Docket Item # 2
BAR CASE # 2015-0180

BAR Meeting
July 1, 2015

ISSUE: Historic Warehouse

LOCATION: 2 Duke Street

NO. 2 DUKE - CANOPY / OTHER DETAILS

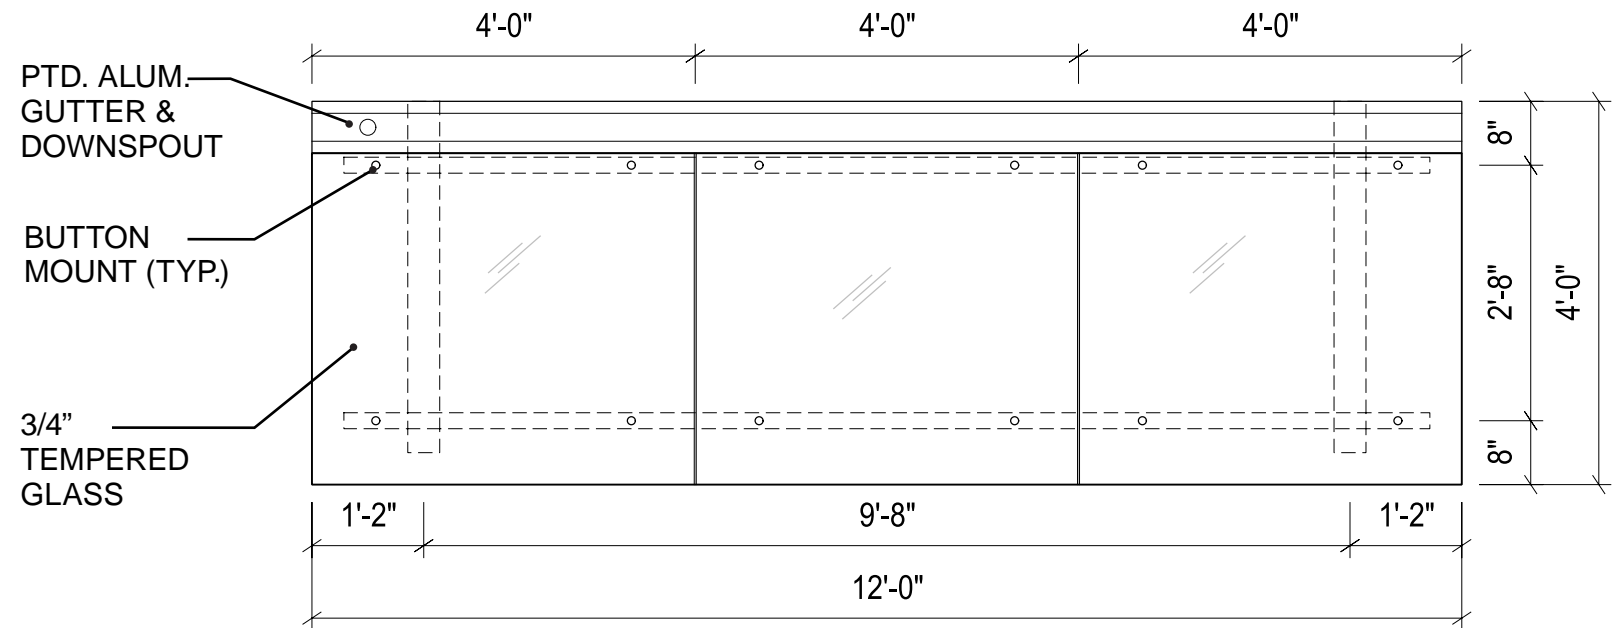
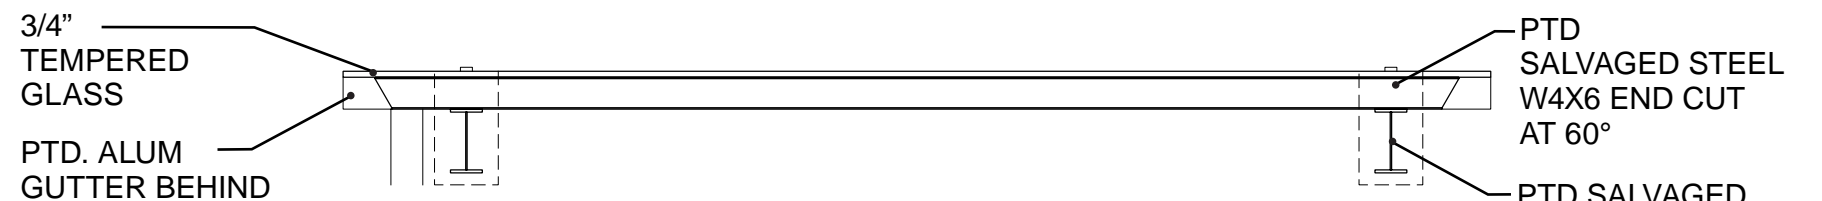
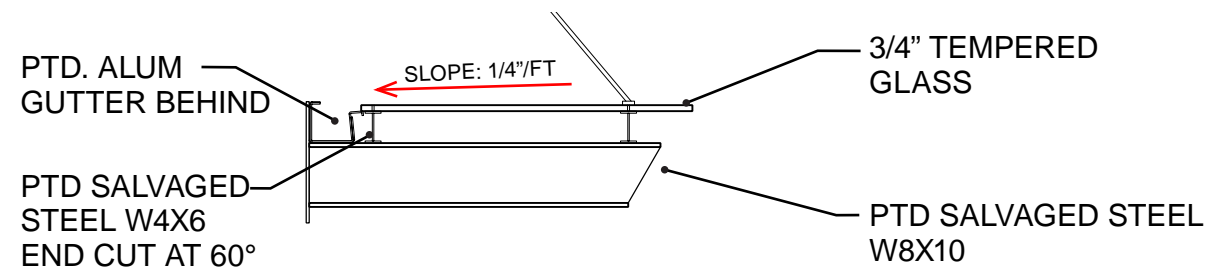
Mr. Carlin inquired whether the sliding doors would be on a track (yes, according to applicant). He noted that this building presented an opportunity for a mixed use area. He liked the canopy detailing above the entrances. He noted it was important to provide a comprehensive sign plan for the site, particularly to distinguish the more public areas from the residential sections. He asked that the stair design at the north entrance be refined so that the railings could be against the wall. Mr. Burkhart said he would look into it.

Ms. Kelley said that she thought it was a wonderful project and liked the entry canopies.

Mr. von Senden inquired how the applicant would work with staff regarding the partial demolition and rehabilitation. Mr. Burkhart responded that they have hired a technical preservation team and will collaborate with staff. He also asked about whether there will be clear glazing for the glass canopy. Mr. Burkhart said it would have a light tint because completely clear glazing would get dirty but that it would be as clear as possible.

At the previous concept reviews, some BAR members opposed a suspended projecting canopy over the entrance. The applicant still proposes such a canopy but has presented a more refined and visually light canopy than the previous design. The canopies are proposed for both the north and south entrances to the building. The applicant has stated in discussions with staff that they believe that canopies are needed to help identify the entrances, provide weather protection above the entry doors and steps, and to enhance this space for retail use by further differentiating this building from the future residential townhouses that will be located immediately to the west. The proposed canopies are a contemporary glass and steel design that recall the suspended metal canopies common to this type warehouse and are easily removable if desired in the future. Therefore, staff finds that the refined and more delicate canopies proposed are appropriate when considered in respect to the overall site arrangement and mix of residential and commercial uses here.

WINDOW DETAILS

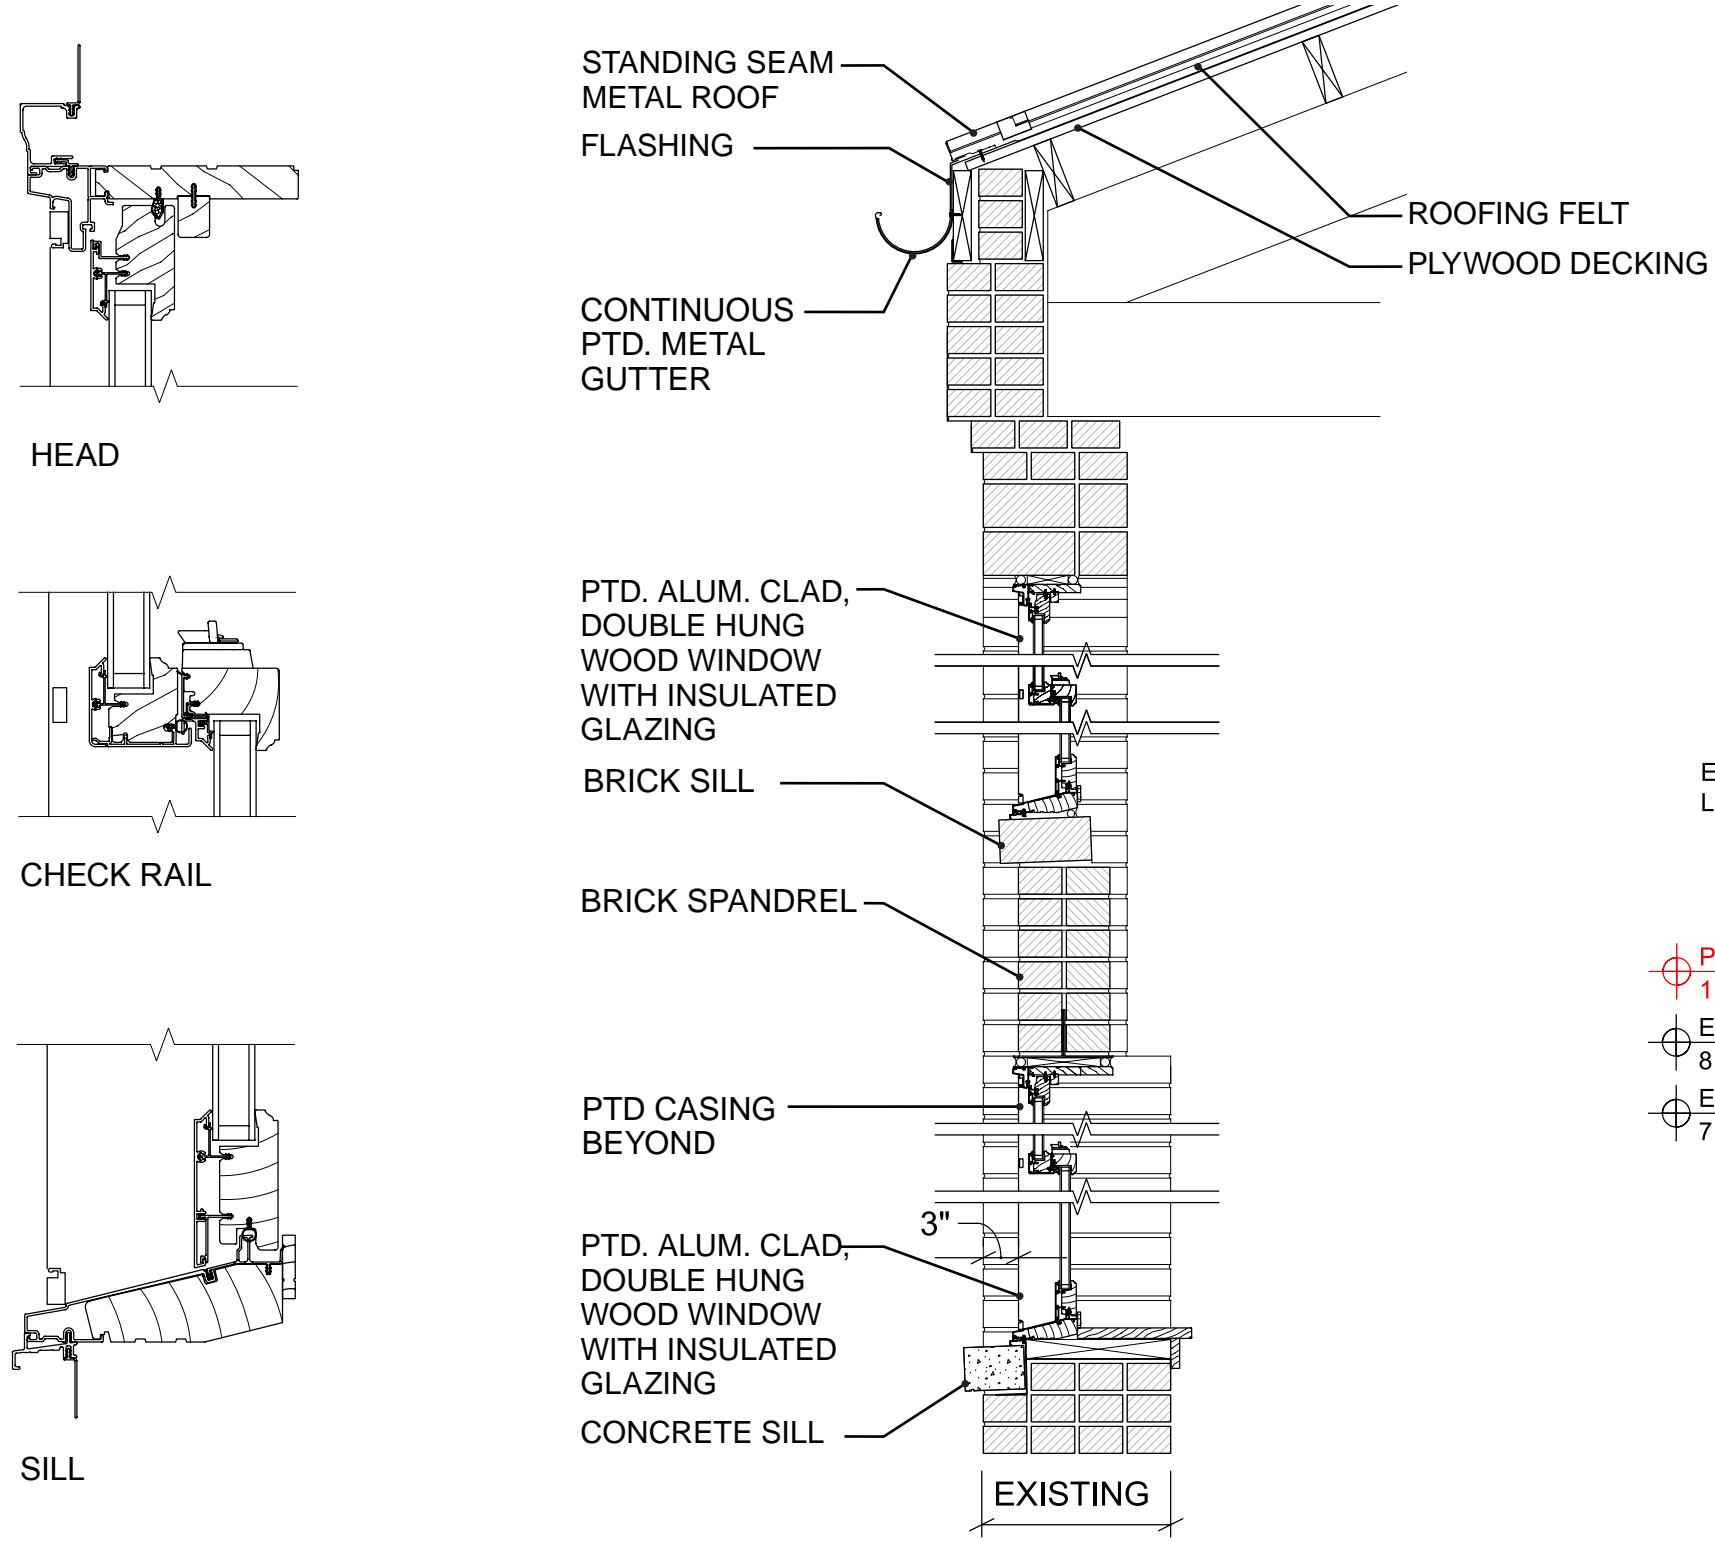
The applicant has proposed a high quality aluminum clad wood window that meets the BAR's performance specifications for buildings constructed after 1965. However, under *the BAR Window Policy*, painted wood windows would be most appropriate and the only window type that staff could administratively approve for this early building. Although all of the window openings have been altered and no original windows remain, and with the understanding that this is an adaptive use of a utilitarian warehouse and not a museum restoration, staff still finds that a painted wood window would be more historically appropriate to represent the building's original date of construction, particularly once it is surrounded by new construction. Therefore, staff recommends that the BAR approve painted wood windows, consistent with the approved policy for all early residential and commercial buildings.

WALL SECTION

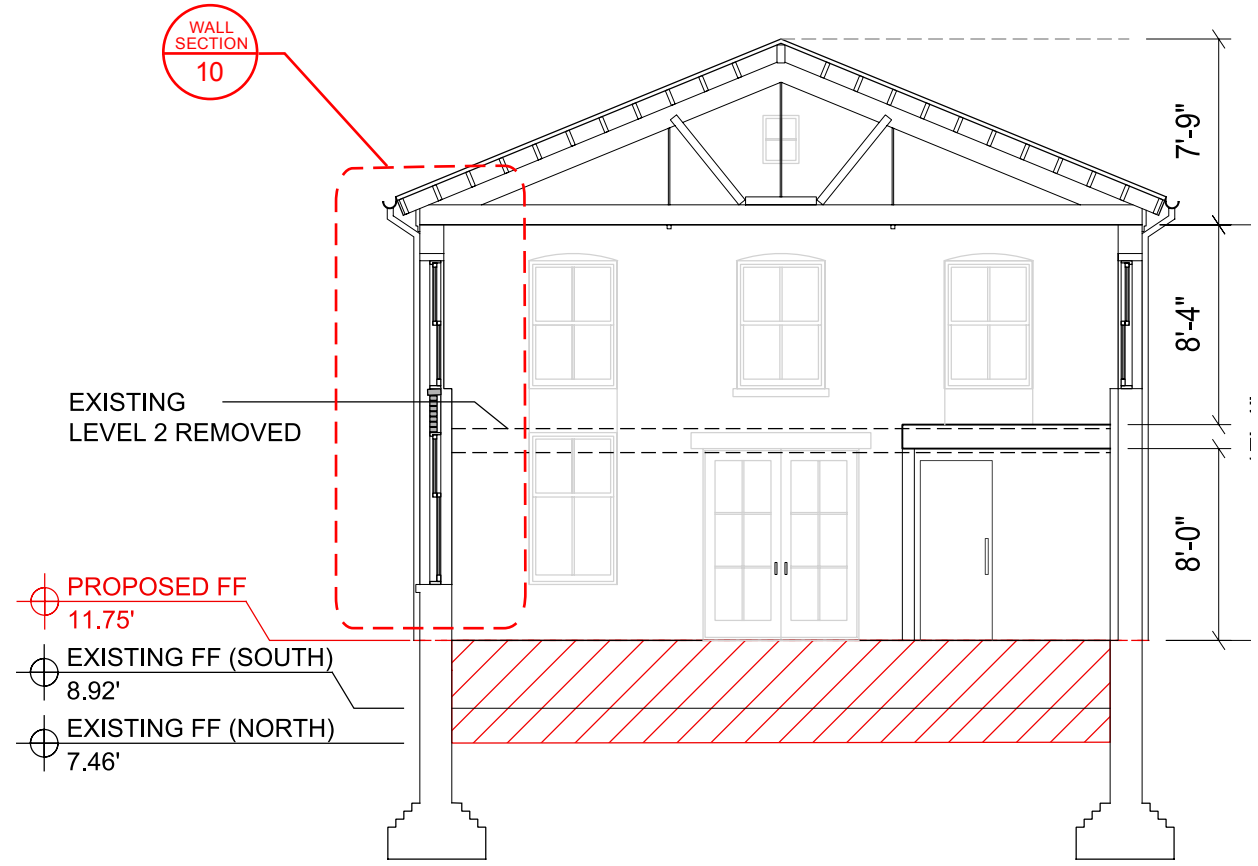
Mr. Neale said that the proposal was well-done but noted that the gutter/roof detail needed to be corrected in the wall sections to reflect the overhang.
